Access Compliance Report

Public Rights-of-Way

Intersection ID: 10038891	Main Street: STIRLINGSHIRE_CT	Cross Street: N/A	Location: SW
ADA ID: 250F8600A193	Ramp Type: BlendTrans1	Initial Pass/Fail: Pass	Overall Compliance: No
Severity Score: 0.25			
Codes/Mitigation Info/Possible Solution		Field Measurements/Component Compliance

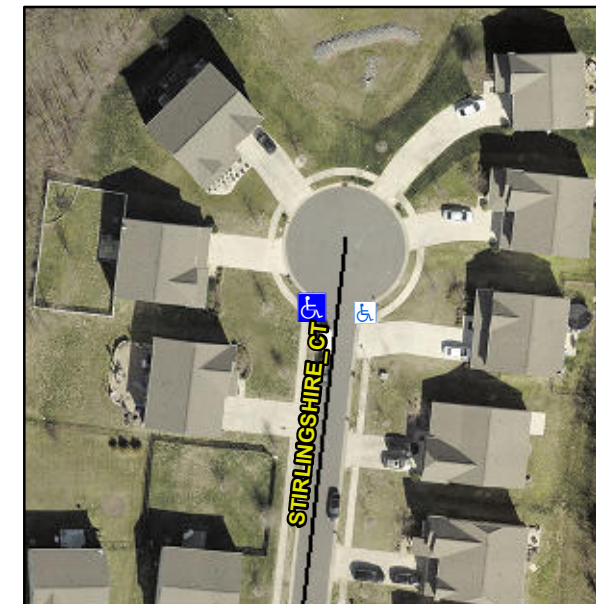
R304.5.3, R304.2.1, R304.2.2-Perp, R304.3.2-Para, R305.2

Compliance	Description	Data	Compliance	Description	Data
N/A	Ramp Length (in)	47.5	Yes	BlendTrans Slope (%)	3.6
Yes	Ramp Width (in)	48.0	No	BlendTrans XSlope (%)	2.3
N/A	Flare Type LT	Sloped	N/A	Flare Type RT	Sloped
N/A	Flare Slope LT (%)	5.0	N/A	Flare Slope RT (%)	2.6
N/A	Flare Traversable LT?	No	N/A	Flare Traversable RT?	No
Yes	Landing Length (in)	48.0	Yes	DWS Provided?	Yes
No	Landing Width (in)	47.5	Yes	DWS Contrast?	Yes
No	Landing Slope (%)	5.6	Yes	DWS Length (in)	24.0
No	Landing X Slope (%)	3.3	Yes	DWS Full Width?	Yes
N/A	Landing Curb? (Y/N)	No	No	DWS Offset (in)	4.0
N/A	Shared Landing?	No			
Yes	Gutter Ponding?	No	Yes	Gutter Slope (%)	2.6
Yes	Gutter Lip Ht (in)	0.0	Yes	Gutter X Slope (%)	1.3
N/A	Painted X Walk1?	No	N/A	Painted X Walk2?	N/A
	X Walk 1 Direction	To E		X Walk 2 Direction	N/A
	X Walk 1 Width (in)	N/A		X Walk 2 Width (in)	N/A
	X Walk 1 Slope (%)	3.4		X Walk 2 Slope (%)	N/A
	X Walk 1 X Slope (%)	0.8		X Walk 2 X Slope (%)	N/A

Remove & Replace Curb Ramp With Two New Directional Ramps or Equivalent.
